August 9, 1985

Docket Nos. 50-250
and 50-251

LICENSEE: Florida Power and Light Company
FACILITY: Turkey Point Plant Units 3 and 4
SUBJECT: SUMMARY OF MEETING HELD WITH FLORIDA POWER AND LIGHT
COMPANY, AUGUST 1 1985, REGARDING TURKEY POINT PLANT
DETAILED CONTROL ROOM DESIGN REVIEW

ACTION-INFORMATION REQUIREMENTS DETAILS (AIRD)

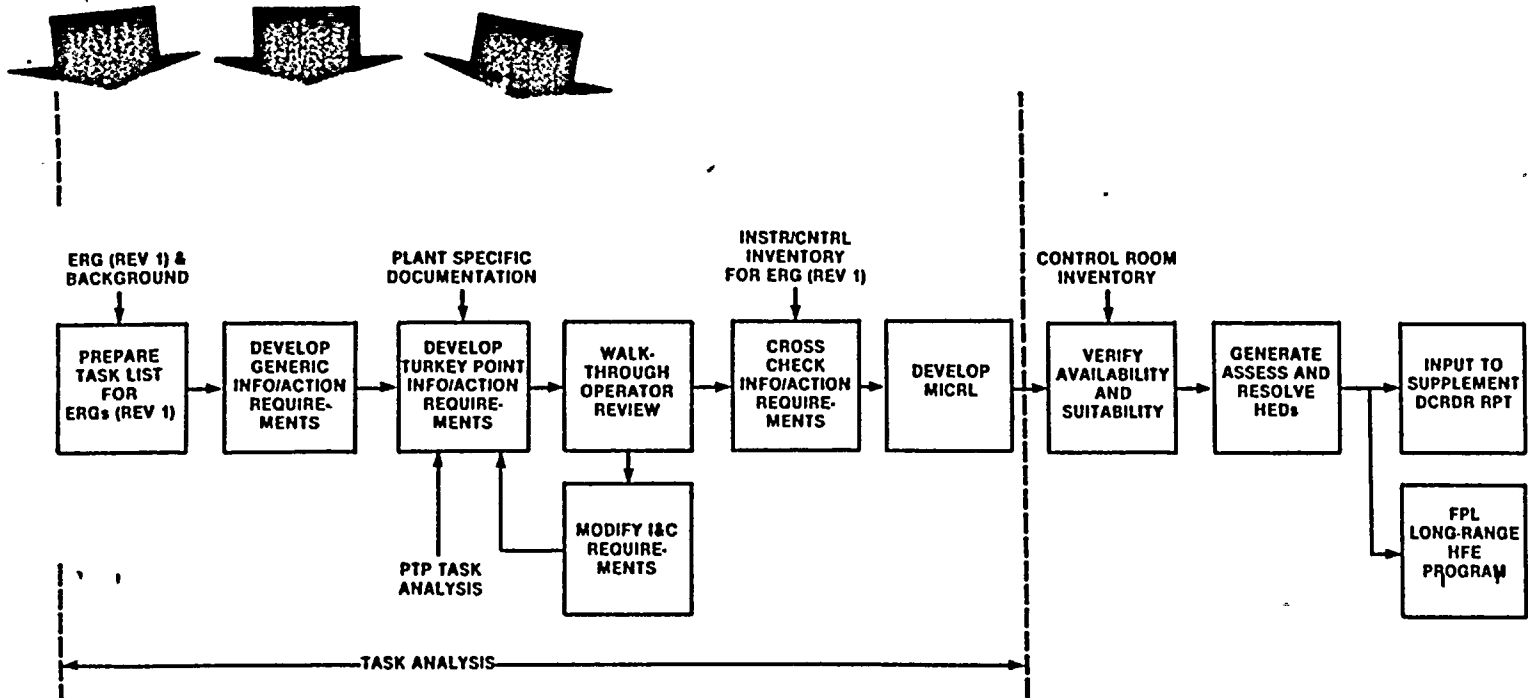
The licensee demonstrated how the methodology was implemented for ERG E-0, Reactor Trip, describing the process and data collection forms. After reviewing the licensee's Action-Information Requirements Detail (AIRD) form, the staff noted that the licensee had not completed the identification of information requirements characteristics. The "Precision" column had not been filled out and other characteristics such as "Range" were not contained on the form. The staff indicated that the task analysis upgrade program, as implemented for ERG E-0, Reactor Trip, was incomplete. The licensee agreed with the staff and committed to provide the additional information on the appropriate data collection forms.
